July 15, 2015

Mr. Guy Donaldson, Chief
Air Planning Section (6PD-L)
Environmental Protection Agency, Region 6
1445 Ross Ave, Suite 1200
Dallas, Texas 75202-2733

**Re: Promulgation of Air Quality Implementation Plans; State of Arkansas;
Regional Haze and Interstate Visibility Transport Federal Implementation Plan;
Docket No. EPA-R06-OAR-2015-0189**

Figure 1 Reasonable Progress Assessment Upper Buffalo Wilderness Area, Arkansas 20% Worst Days

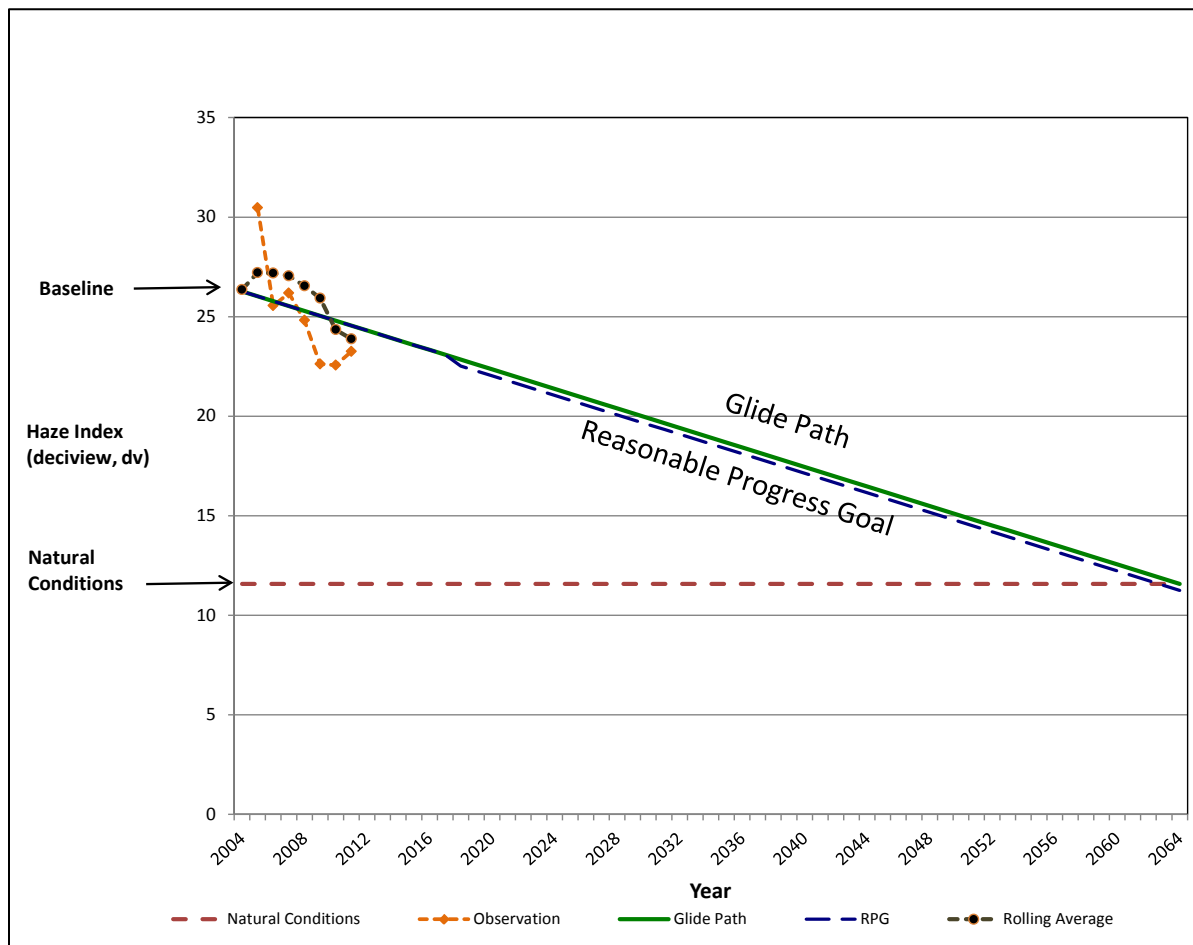
Despite Arkansas being on schedule to meet or beat the trajectory needed to achieve background visibility conditions by 2064, EPA is proposing more stringent RPGs that would require unnecessary additional controls. Specifically, EPA is requiring additional controls on Entergy Independence Units 1 and 2.⁷³ EPA’s proposed RPGs are more aggressive, which is inconsistent with EPA’s approach in certain other states that allow RPGs that would improve visibility over a much longer timeframe.⁷⁴

Figure 2.1. Percent Contribution of Major Haze Components to 20% Worst Days at Caney Creek Wilderness Area, Arkansas, for the Current Five-Year Average (2007-2011)

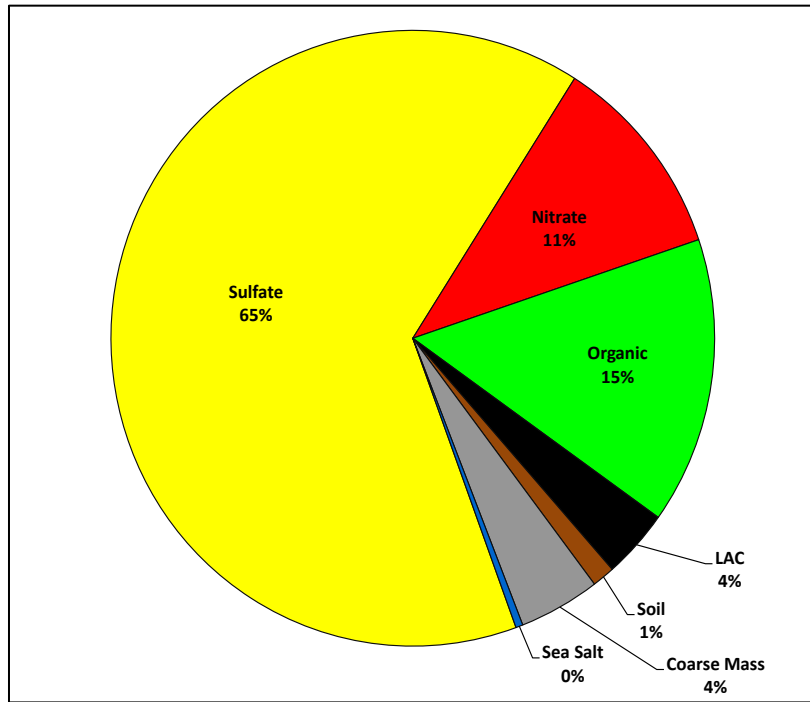
Chapter 2.1: The description of pollutant contributions to haze on the 20% worst days at Caney Creek and Upper Buffalo Wilderness Areas (WAs) is good. Figures 2.1 and 2.2 demonstrate that sulfate is the largest contributor to haze of the 20% worst days. Figure 2.3 demonstrates that Electric Generating Units (EGU) and non-EGU point sources are the largest contributors to sulfur dioxide (SO₂) emissions in Arkansas. Therefore we would expect Arkansas to concentrate on reducing point source SO₂ emissions in the long-term strategy.

Comment 1: In Chapter 2.1, the description of pollutant contributions to haze on the 20% worst days at Caney Creek and Upper Buffalo Wilderness Areas is good. Figures 2.1 and 2.2 demonstrate that sulfate is the largest contributor to haze of the 20% worst days. Figure 2.3 demonstrates that Electric Generating Units (EGU) and non-EGU point sources are the largest contributors to sulfur dioxide (SO₂) emissions in Arkansas. Therefore, NPS would expect Arkansas to concentrate on reducing point source SO₂ emissions in the long-term strategy.
